Site Plan Review and Appearance Board

Meeting: November 13, 2019	File No.: 2019-256-SPF-SPR-CLIII (Waiver)	Application Name: Pierre Delray Phase 1 (SunTrust Bank)
----------------------------	-------------------------------------------	---------------------------------------------------------

A waiver request seeking relief from LDR Section 4.4.13 (E)(4)(e)1., a, Table 4.4.13 (I), A, to allow for the proposed building storefront façade on the north side of the property to encroach 2'-2" into the 10' required front setback.

302 E. Atlantic Avenue
Pierre Delray I (SunTrust Bank)

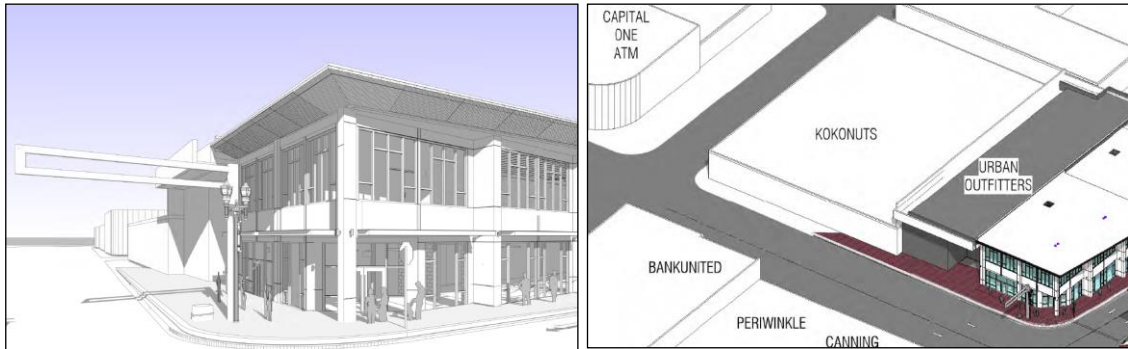
The subject site located at 302 E. Atlantic Avenue is not located adjacent to any existing bike lanes. The proposed waiver to reduce the 10' minimum required storefront setback to 7'-10" in order to increase the ground floor retail space does not appear to degrade the existing street and sidewalk network or negatively impact any adopted bicycle/pedestrian master plan. Sites along Atlantic Avenue are required to provide a minimum 15' streetscape area, and storefronts are required to have a minimum 10' setback. The sidewalk network exists along the Atlantic Avenue corridor. The waiver requested would allow for the first floor storefront façade to extend 2'-2" into the front setback, in order to increase the square footage of the retail space on the ground floor, and replacing the existing arcade. The arcade which was created prior to the current LDR is non-conforming. LDR Section 4.4.13 (E)(4)(f)1.,a., says that "arcades shall extend over the sidewalk and not parallel to the sidewalk, allowing pedestrians to bypass storefront windows." The replacement of the arcade with a decreased storefront depth that will aid in maintaining consistency of the frontage along the corridor. The existing arcade creates an inconsistency in the pedestrian flow by creating an offset in sidewalk width.

Existing storefront depth along the corridor

Proposed Storefront
